SEMINOLE COUNTY GOVERNMENT AGENDA MEMORANDUM

SUBJECT: Change Order #3 to CC-0751A-06/TLR - CR46A Phase III, CR15 to Old Lake Mary Road

SEMINOLE COUNTY, FLORIDA
CHANGE ORDER FOR CONSTRUCTION PROJECTS

CONTRACT NO: CC-0751A-06/TLR INITIATION DATE: 01-23-2008 ORIGINAL CONTRACT DATE: 11-07-2006
CHANGE ORDER NO: 03 ACCOUNT NO: _____ ARCH/ENG PROJECT:# _____
CONTRACT FOR: CR-46A Phase III, CR-15 Country Club Rd to Old Lake Mary Rd

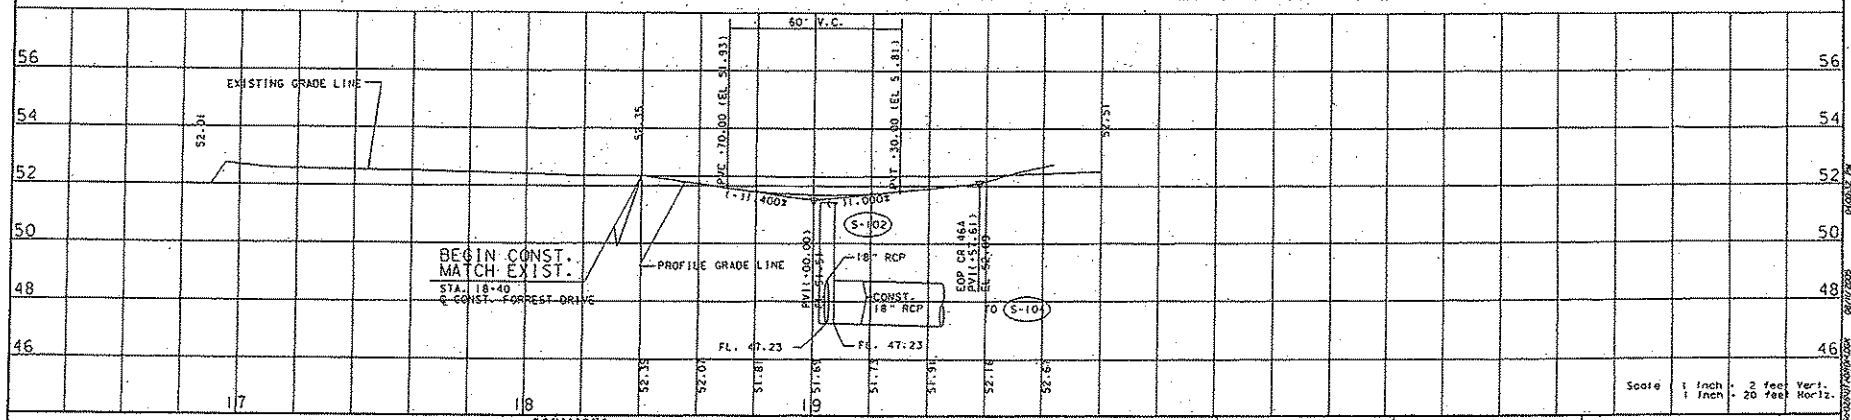
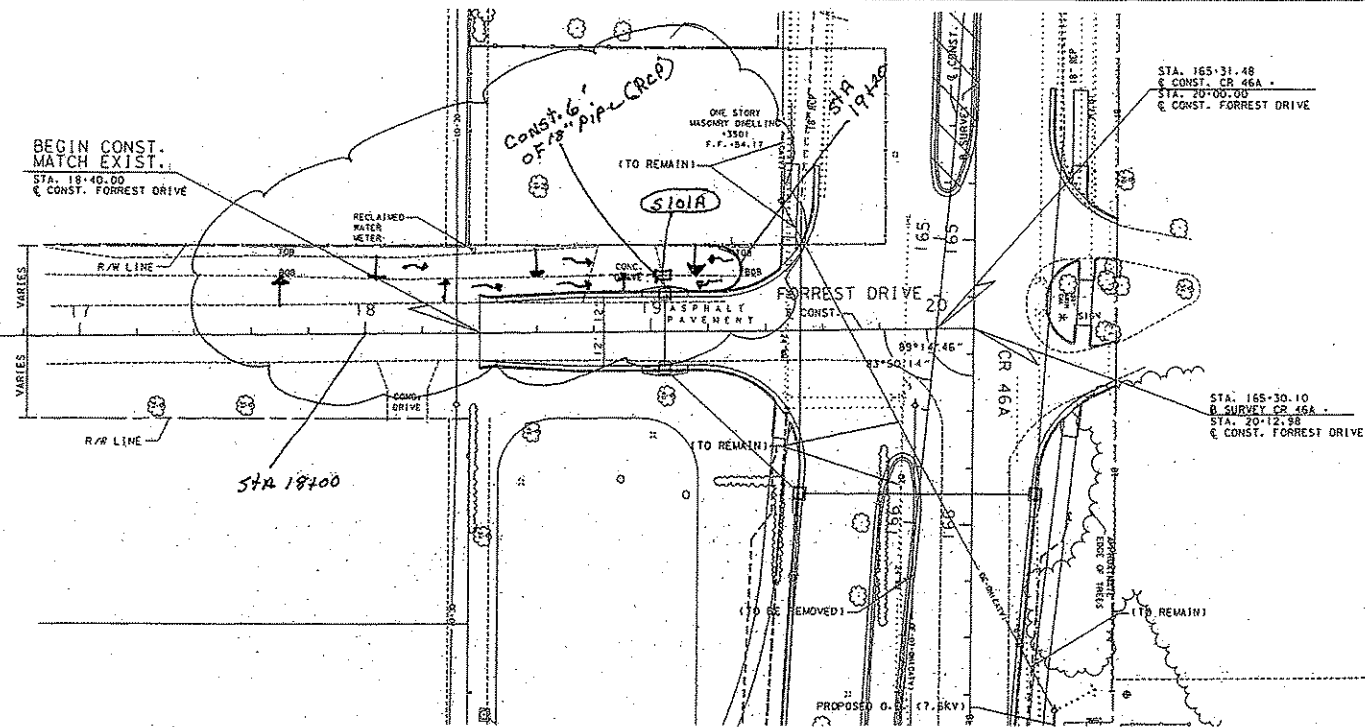
The narrative and sketch are acceptable to the County. Thank you. Please forward the drainage improvement narrative and sketch to the contractor for a cost proposal. Also, please keep in mind that the County would like to see a gradual slope to the proposed D.B.I.

Bill, attached is a sketch and narrative regarding the added drainage structure on Forrest Drive. Please review. We will not forward to the Contractor until we hear from either you or Steve that it's good to go.

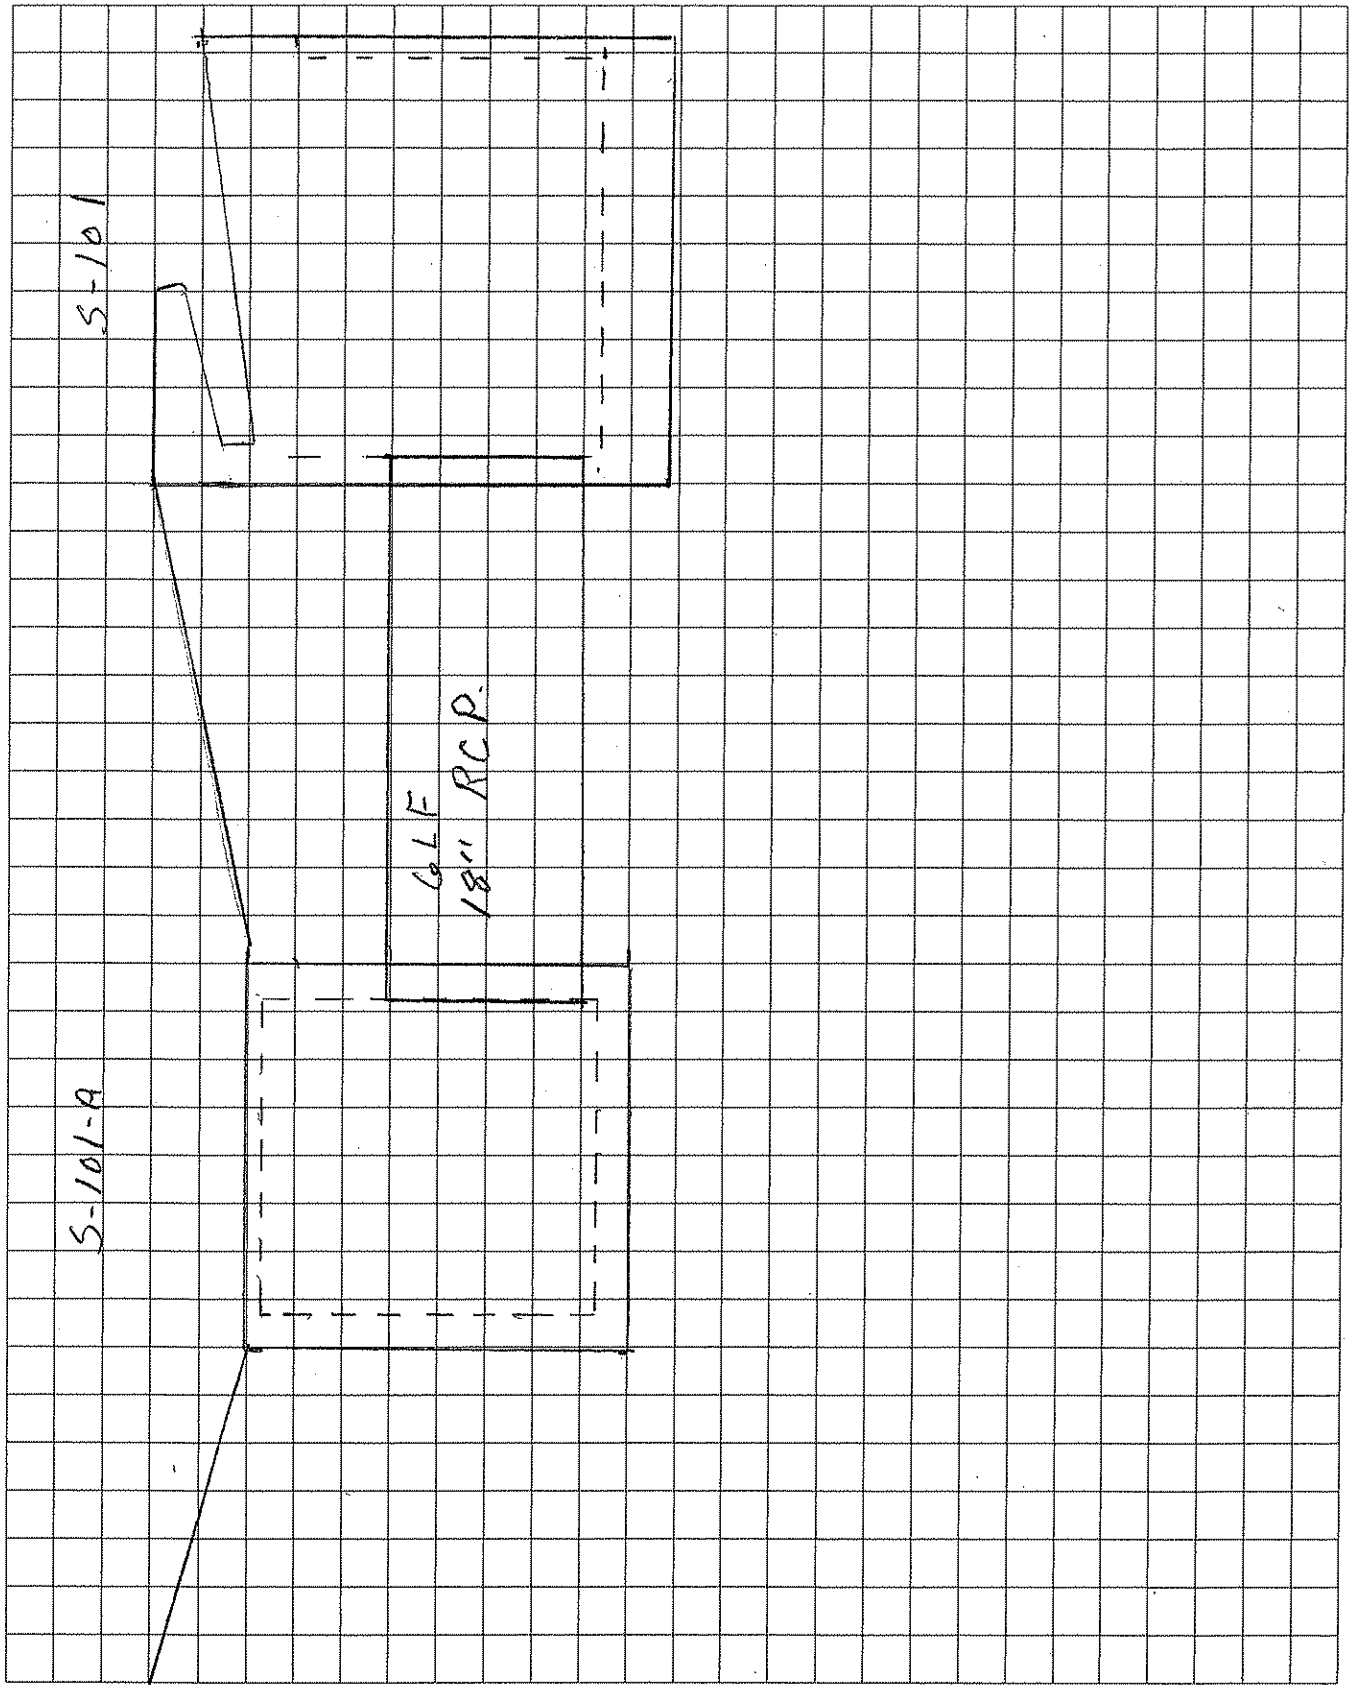
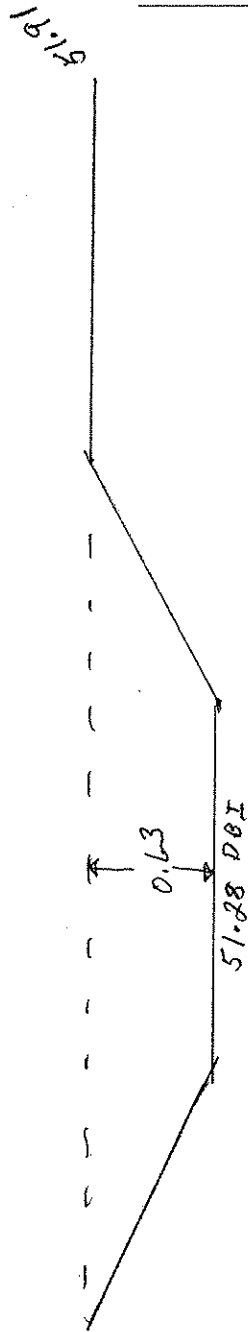
Additional drainage will be needed behind the F-curb in the Lt. roadway on Forrest Drive from station 18+00 to station 19+20± Lt.

A new drainage structure will need to be installed (S-101-A) behind existing structure S-101 at station 19+05 Lt. roadway. The new structure will be a DBI Type "C" per Standard Index 232 sheet 1 of 5. Flow line elevation should be 47.50 and the elevation of the grate should be at 51.28. Drainage structure S-101 will need to be modified to receive the 6-LF of 18-in. RCP from proposed structure S-101-A. Cut and remove F-curb crossing the existing ditch at station 18+40. Grade new ditch from station 18+30± to new DBI S-101-A at station 19+05. Back grade ditch from station 19+20 to structure S-101-A.

BEGIN CONST.
MATCH EXIST.
STA. 18+40.00
@ CONST. FORREST DRIVE

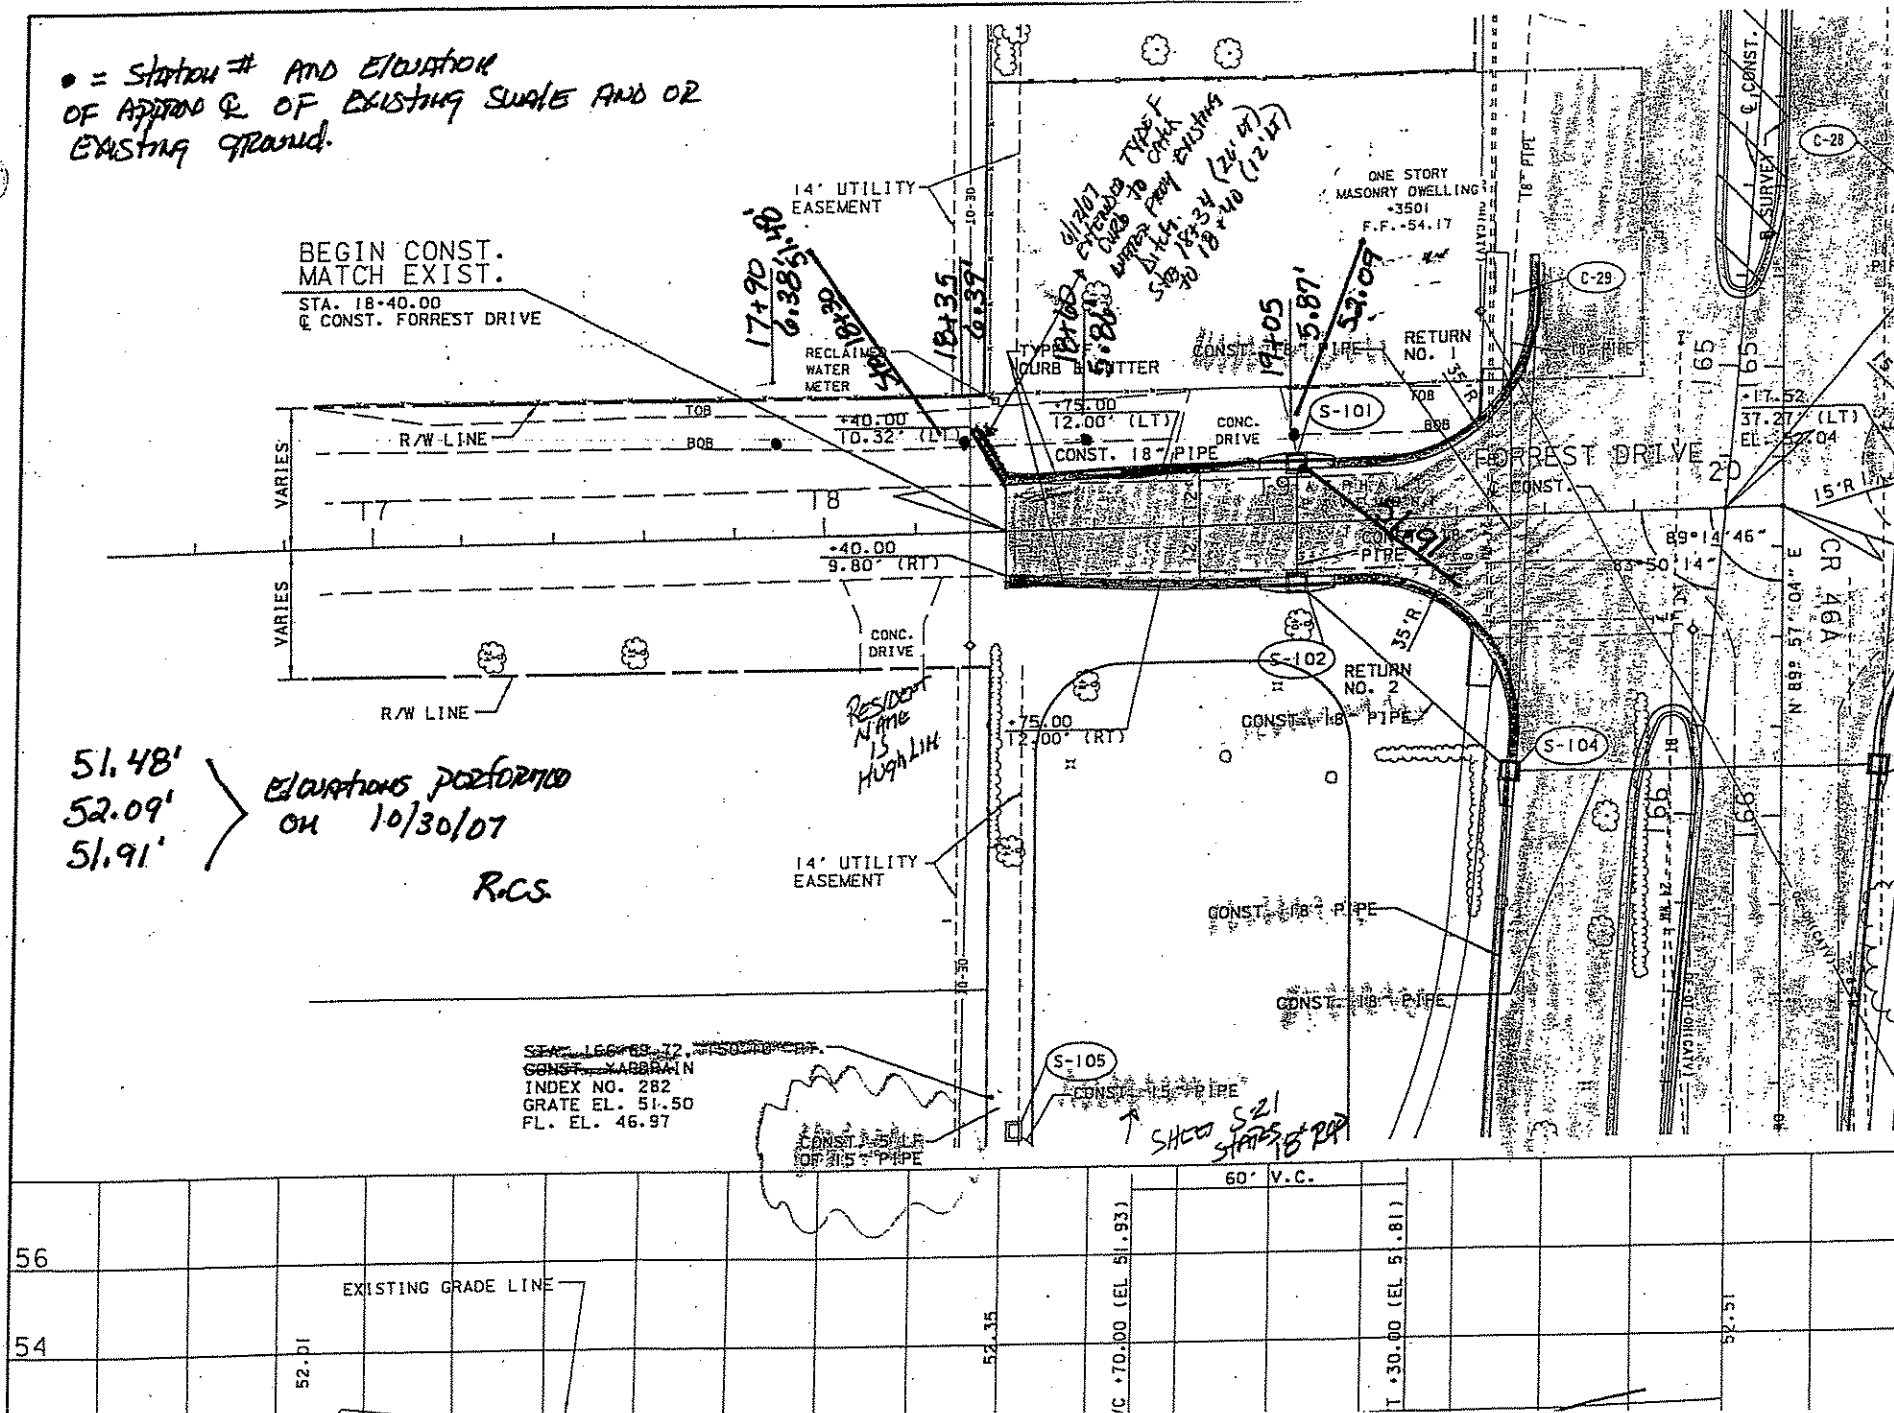
- D. A new drainage structure will need to be installed (S-101A) behind existing structure S-101 at station 19+05 Lt. on Forrest Drive the new structure DBI Type "C". Install 6-ft. of 18-in. RCP between structures S-101 and S-101A at a flow line of 47.50 Ft. Remove existing F-curb crossing ditch at station 18+40 Lt. Modify existing F-curb at station 18+40 Lt. to a flared end. Grade new ditch from station 18+00 to 19+20.

- D. The additional drainage structure (S-101A) was needed to prevent flooding along Forrest Drive and property owners caused by the new construction on CR-46A and Forrest Drive.
